**PROPOSAL FOR CHANGE – NATIONAL CONSTRUCTION CODE 2014 -
VOLUME ONE: SECTION J ENERGY EFFICIENCY**

PROPOSAL FOR CHANGE – SUMMARY OF ITEMS

Figure 1 – Proposed Column Insulation

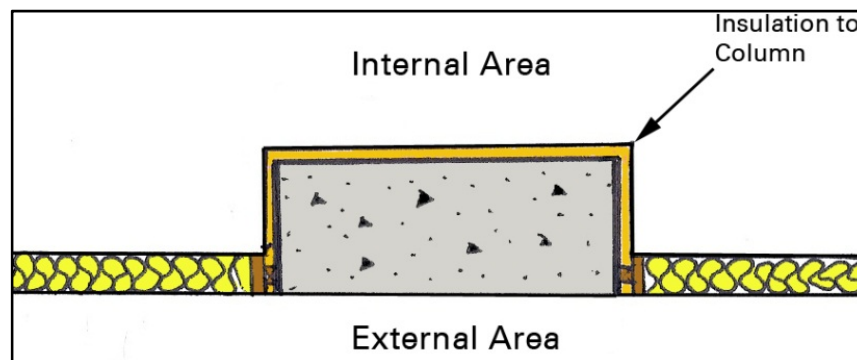
THE CURRENT PROBLEM

The term "Supporting Member" as captured under Part J1.2 - "Thermal construction – general – (a)(i)" is given by example as "studs, noggins, joists, furring channels and the like". These examples are by reference typical to lightweight timber or metal framed wall; or heavyweight masonry or concrete wall with furring channel to the internal face.

The current provisions do not adequately address the treatment of concrete column. On the proviso that concrete columns are captured under the definition of "Supporting Member", then concrete column should also be addressed by a specific sub-clause mandating that the concrete column be insulated in accordance with Part J1.5(a) when forming part of the thermal building envelope.

It is crucial that all external envelope columns within conditioned spaces be insulated on the internal sides and rear facing surface. To exclude insulation in this configuration would be to create a thermal bridge, and significantly impact the effectiveness of the building thermal envelope, and thus undermine Section J –Objective J01: "To reduce greenhouse gas emissions".

- Part J1.5 - Walls (a). Modify clause to read as follows:

(a) Each part of an external wall that is part of the envelope, including columns forming part of the envelope, other than of...."

The following figure is provided to illustrate our recommendation. The surfaces in “orange” identify where insulation is to be placed around the concrete column. (Note: This drawing is not to scale, nor does it accurately represent any specific insulation type).

Figure No. 3 – Detail: Insulation Backed Spandrel Glazing.

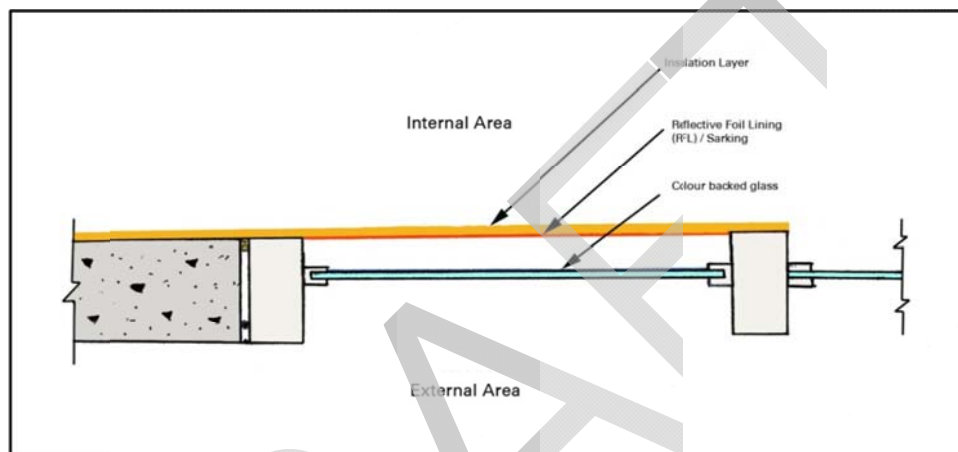
THE CURRENT PROBLEM

NCC Part J2 – Glazing disregards opaque (non-transparent or non-translucent elements and its supporting frame located in the envelope) from its calculation parameters. The application of insulation to spandrel glazing sections is therefore called up under Part J1.2 (a) (i) and Part J1.5 Walls. This would allow for a variety of insulation detailing including installation directly to the rear (internal) face of the glass, and leaving the window framing exposed. This represents a serious design flaw with respect to thermal bridging and overall building thermal envelope design.

We advocate that the suitable application of spandrel glazing insulation be rigorously considered and addressed to achieve greater mitigation of thermal bridging from window frames. Notwithstanding the thermal bridging effect, there are also significant issues such as glass fracturing and fatigue failure associated with inappropriate or contiguous insulation backings of spandrel glass.

THE PROPOSAL

Amend Part J1.2 (a) (i) and add an additional clause under J1.5 Walls to represent the suitably compliant application of spandrel glazing insulation.

Provide a detail contained within an updated NCC Section J Handbook depicting the application of spandrel glazing insulation with window frame sections to amply address the thermal bridging effect.
